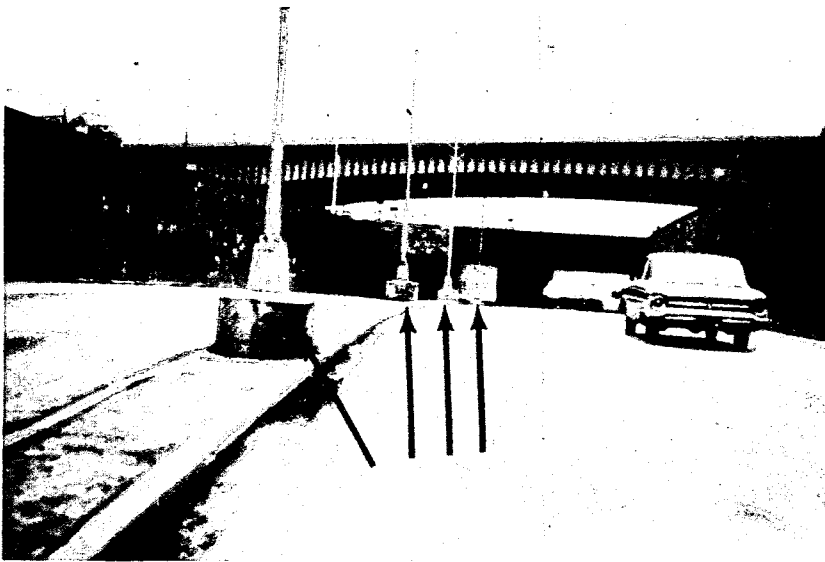
Here you see they eliminated all the bridge abutments, but they put concrete stumps in the center here under the light poles. This is wrong. You have a low curb and somebody can cross over and have a head-on crash, and if they hit these light posts, they are in trouble.

This would be the proper way of doing it. Why not build a barrier and have no maintenance at all on your light posts?
